Re: Bull's Head Street Improvements Proposal of 2025.02.04

W Main & Genesee Street Protected Intersection Design

AASHTO Bike Guide, Page 7-37

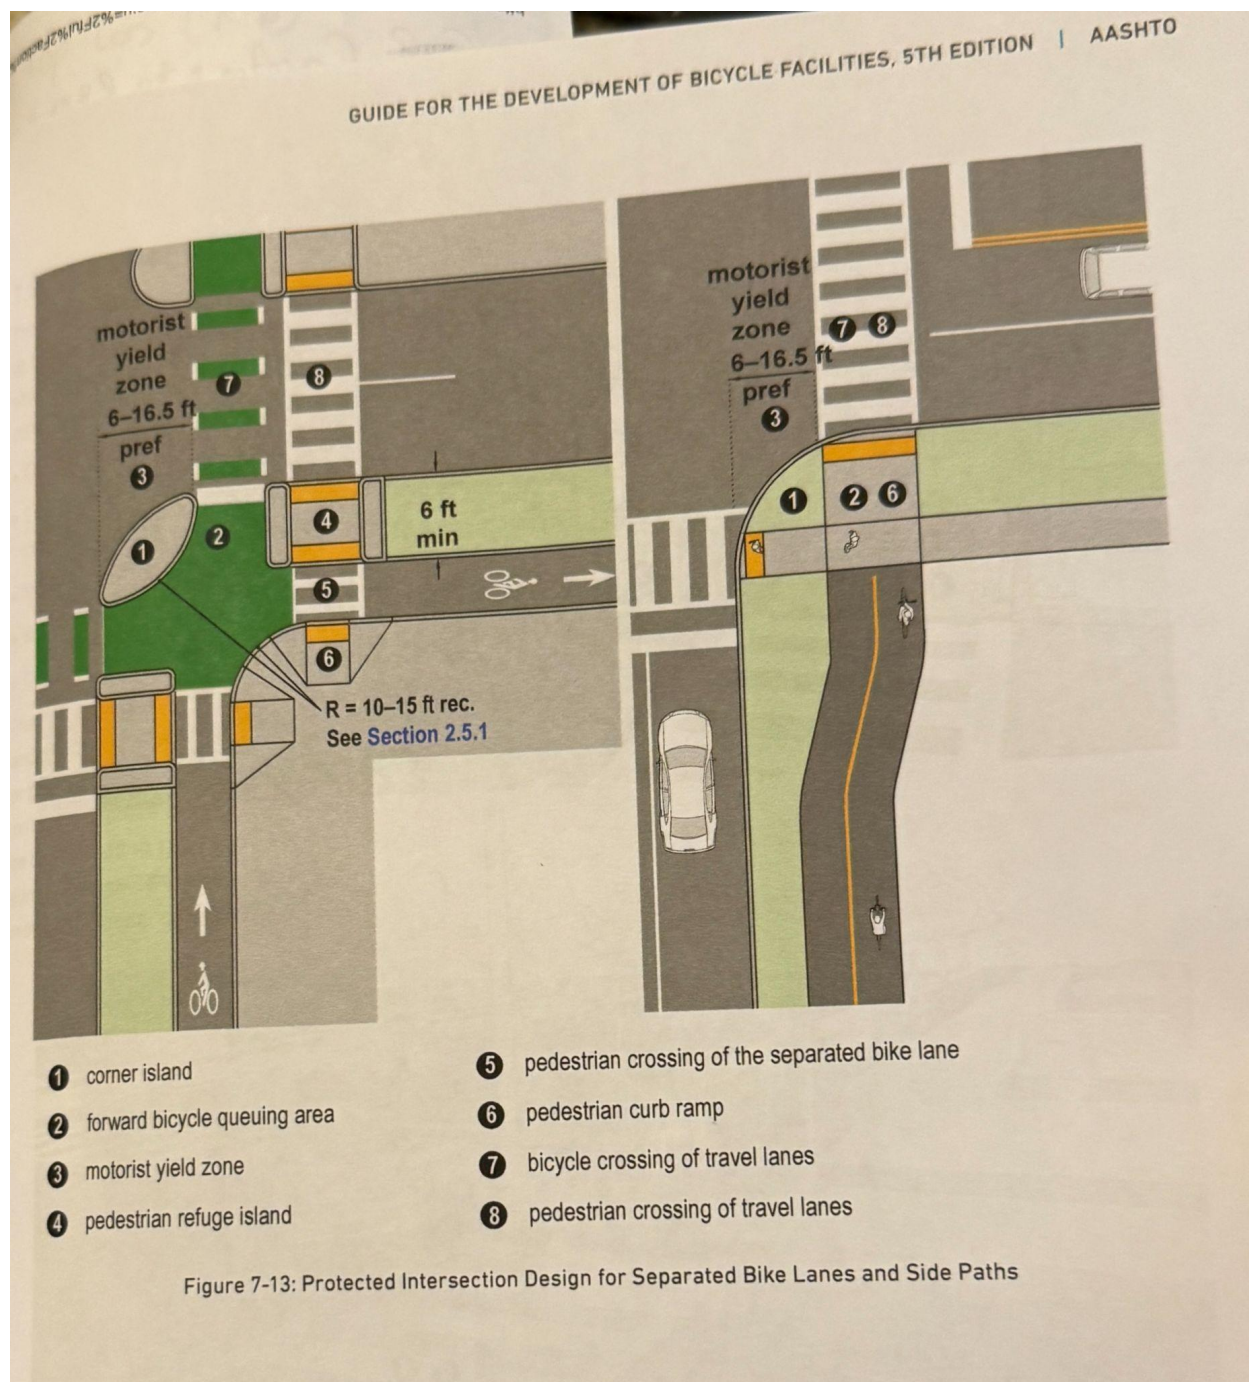
Reconnect Rochester’s previous input stressed the need for the intersection of West Main Street and Genesee Street to be constructed as a protected intersection. Chapter 7 of the AASHTO Bike Guide discusses the design details of separated bike lanes and side paths. Section 7.2.1 discusses the tradeoffs between retrofit and permanent designs saying, “...capital improvement projects should also incorporate the preferred design features such as sloping curbed medians instead of flexible delineator posts and pavement markings, and protected intersections instead of mixing zones” (AASHTO 7.2.1).

Section 7.9 details intersection principles including: minimizing exposure to conflicts, reducing speeds at conflict points, providing clear transitions when elevation changes, signaling right-of-way priority, having clear sight distance, and restricting motor vehicles from driving in spaces for bikes. “Considering the principles discussed in sections 7.9.1 through 7.9.5, **protected intersections are preferred over designs that require bicyclists to mix with motor vehicle traffic**. Well-designed protected intersections are intuitive and comfortable, provide clear right-of-way assignment, promote predictability of movement, and allow eye contact between motorists, bicyclists, and pedestrians. **They also clearly define pedestrian and bicyclist operating spaces within the intersection and minimize potential conflicts between users**” (AASHTO 7.9.7).

Figures 5-17 and 5-18 from pages 5-54 and 5-55 of the AASHTO Bike Guide

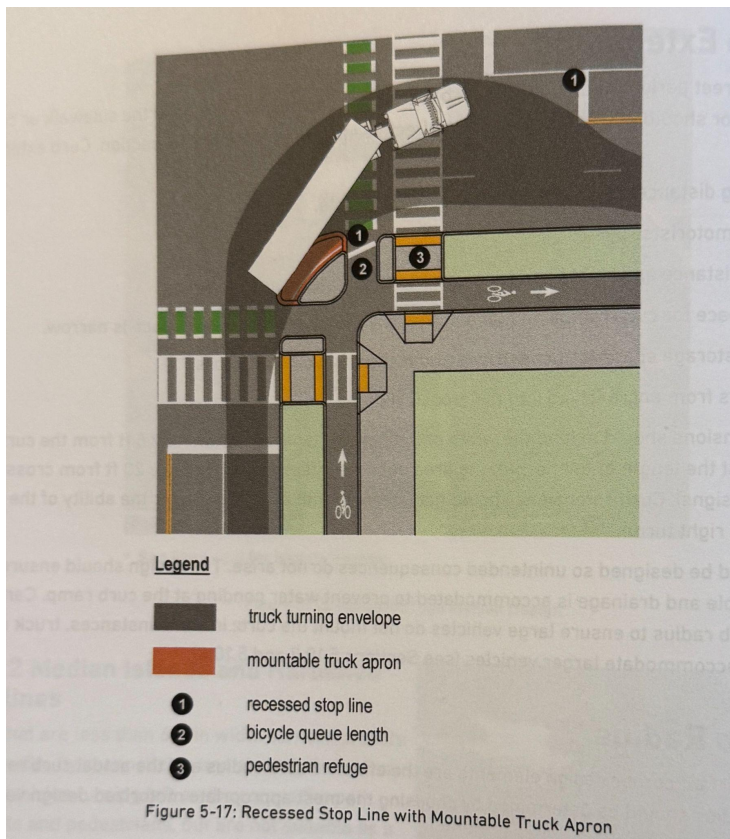
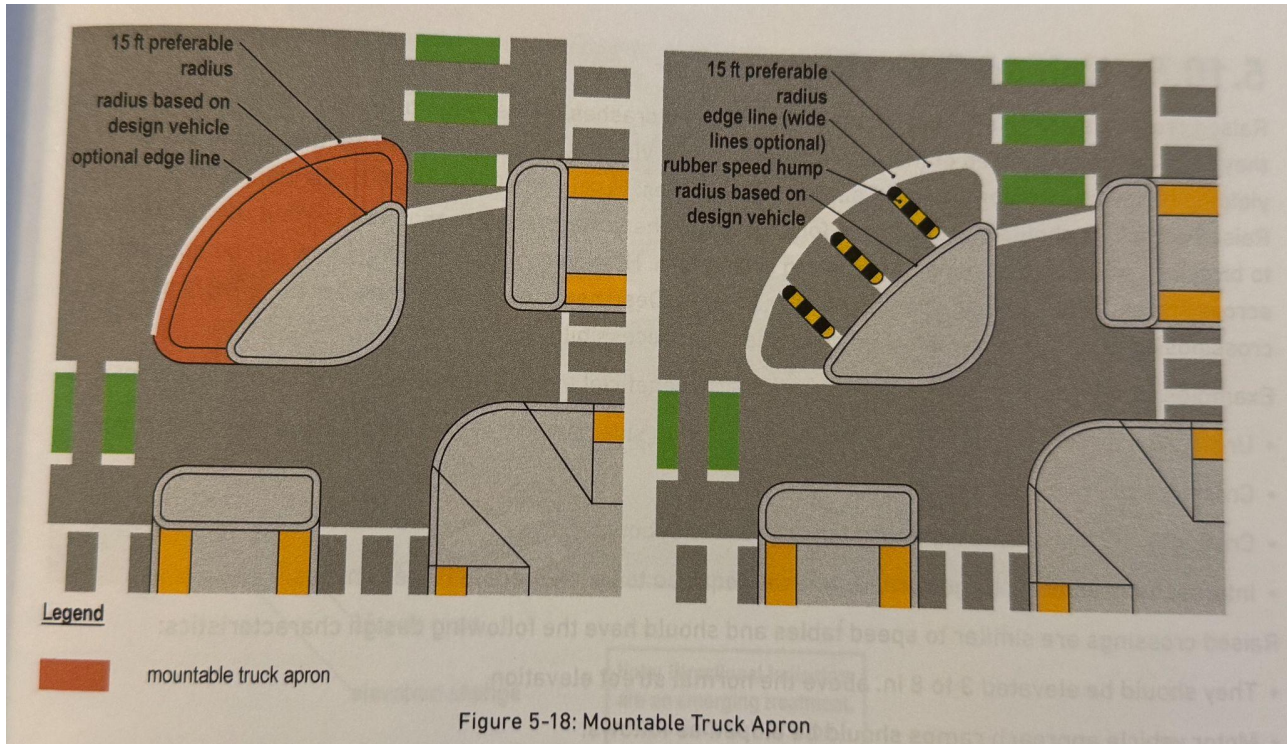
Our previous letter stressed the need to reduce the turning radii of the intersections across this project to prioritize slower speeds. Narrow turn radii can be used while simultaneously allowing larger (WB-50 or WB-67) vehicles to make turns. **We suggest considering the use of Mountable Truck Aprons which slow drivers while allowing trucks to make turns without encroaching on pedestrian and cyclist space.** “Where the design vehicle exceeds an SU-30, a mountable truck apron can be considered to supplement the corner island (see section 5.10.4); however, the corner island should not be eliminated, as it serves important functions in protecting crossing bicyclists and pedestrians and controlling motorist speeds” (AASHTO 7.9.7.1). Other strategies such as recessed stop lines (discussed in AASHTO 5.10.3) can tighten curb radii and allow larger vehicles to make turns. Some of these strategies are depicted in figures 5-17 and 5-18.

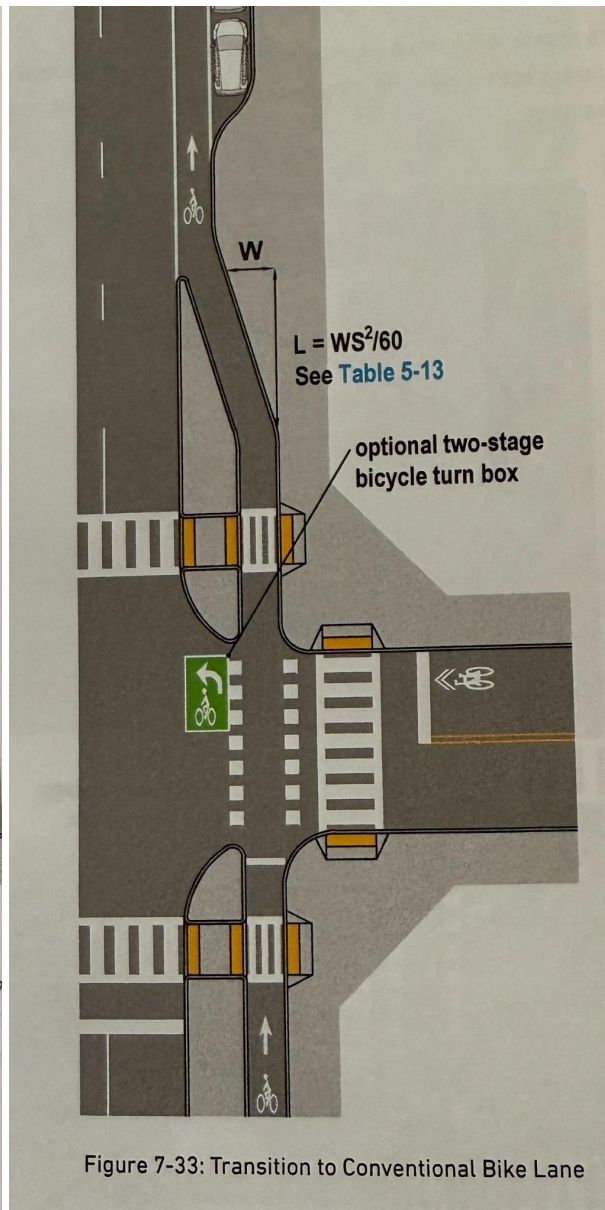
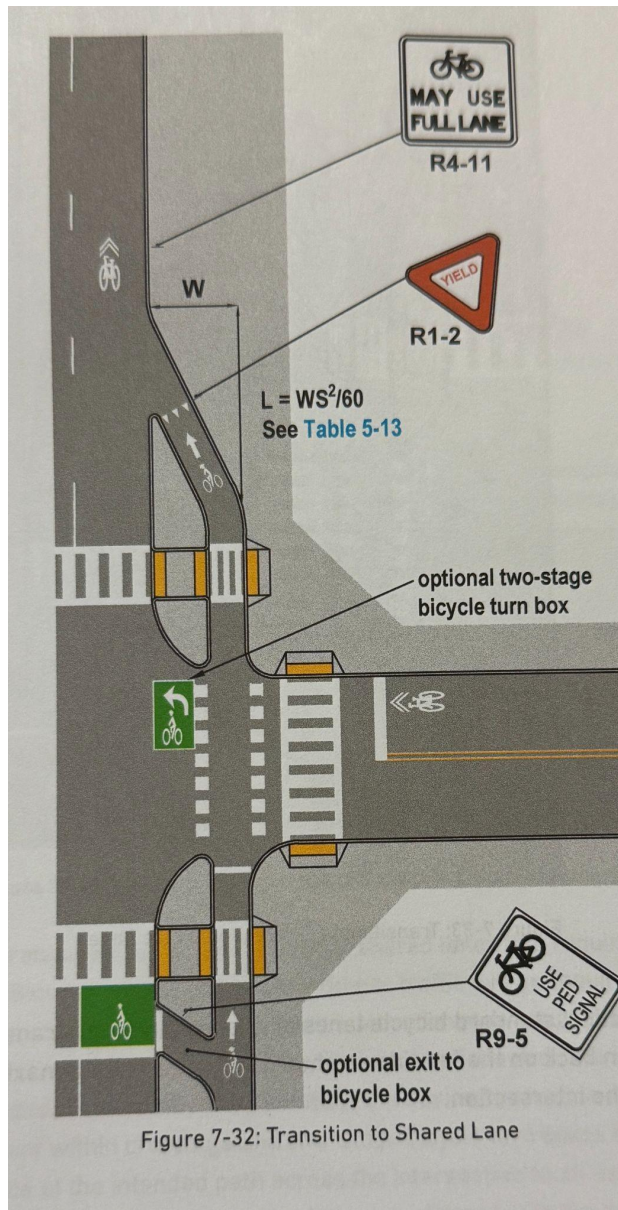
The latest design presented at the public meeting has a narrow cycle track with a small buffer while lane widths remain far above minimum dimensions. Chapter 2 of the [NYSDOT Highway Design Manual](#), updated on January 24th 2025, defines the minimum width of non NHS urban roadways to be 10' in residential and commercial areas such as Bull's Head ([Page 2-60 of NYSDOT HDM](#)). **Using the NYSDOT minimum lane widths on West Main Street as prescribed by AASHTO would result in 7' of savings at the intersection and across the West Main ROW.** These savings can be used to more easily accommodate a protected intersection and/or bring the cycle track width up to AASHTO standard (as discussed below).

Reducing lane widths would also reduce the pedestrian crossing distance which would help to make the intersection safer and easier for pedestrians to cross. Our previous input letter cited [recent scholarship](#) which has demonstrated that wider travel lanes are not safer than narrow lanes contrary to typical traffic engineering knowledge. AASHTO goes on to say: "Research on the effects of 10- to 12-ft travel lane use travel lane widths on crashes for urban and suburban arterial roadways, with posted speeds of 45 mph or less, has found no general indication that the use of narrower widths within this range increases crash rates or decreases motor vehicle capacity. (See chapter 4 References: AASHTO, 2018; Potts, Harwood, and Richard, 2007; Potts, et al., 2007; Macdonald et al., 2008.) Research has also found that narrower lane widths can contribute to lower vehicle operating speeds, which can increase safety for all roadway users" (AASHTO 4.4.2.2).

Figure 7-29, AASHTO Bike Guide on page 7-57

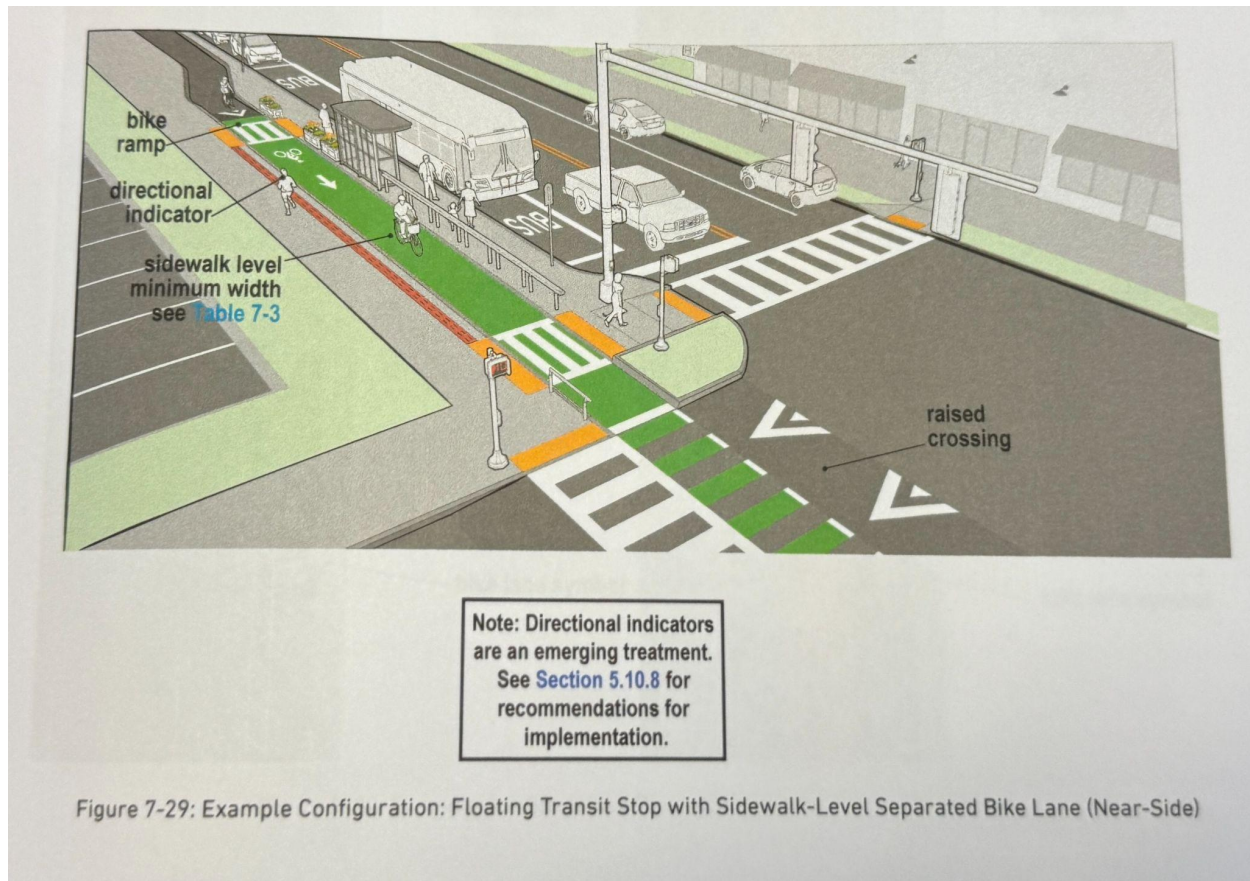
Throughout the project area, protected bike lanes and bus stops should be designed to not conflict with each other. **AASHTO emphasizes “floating transit stops” as the preferred design option** as described in 7.9.14. It is especially important that floating transit stops are considered as new curbs are installed throughout the project as this is the time to implement this design. Floating transit stops can be designed to provide in-lane or pull-out options depending on the bus stop’s constraints.
